Delegated Report

Householder Planning Application

Application No:	20211200
Location:	4 Harden Road, Northfleet, Gravesend, Kent, DA11 7HF
Description:	Formation of vehicular access and hardstanding.
Applicant:	Ivan Chavdarov
Site Visit:	N/A Desktop Assessment

Kent County Council Vehicle Crossing:- Guidance and Self Assessment (2018)

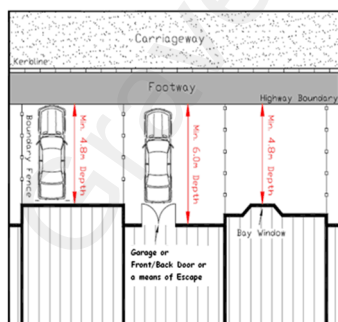
GBC - Highways Officer - As presented I consider this proposal is unacceptable.

Any parking space in front of a door to a property should be a minimum of 6 metres deep to ensure there is adequate pedestrian access/egress to a property particularly in the event of an emergency.

Also to conform to the requirements of SPG4 a parking bay should be 5 metres deep and not 4.8 metres, the depth of the front garden. However, Kent County Council guidance is confusing as their published guidance for carriage crossovers differs to the adopted supplementary planning guidance.

Given the confusion in the depth of parking spaces given the published guidance from KCC I would accept a depth of 4.8 metres, but cannot reduce the depth in front of a door to the property as this relates to emergency access as well as normal access.

* Or at least 6m long where the parking area is in front of a garage or door where adequate means of escape needs to be provided, like a front/back door, escape window etc. If you have any questions on the adequate means of escape please contact your local Kent Fire and Rescue Service, Safety Office.

Given the situation, I can only recommend refusal, but if the applicant were to move the crossover to the opposite end of the front garden, an acceptable layout should be possible. This however will conflict with a lamp column and a utility box on the front wall, both of which will require attention.

There are not considered to be any parking or highway issues related to this proposal. The Highways Officer raised concerns regarding insufficient depth of parking spaces and parking impeding the front door, which is an emergency exit. These concerns have been addressed during the amendments to the proposal. The crossover has been reduced in width and the fencing extended along the frontage, the proposed hardstanding will allow for a vehicle to park at an angle so as not to overhang the curtilage or block the access to the property.
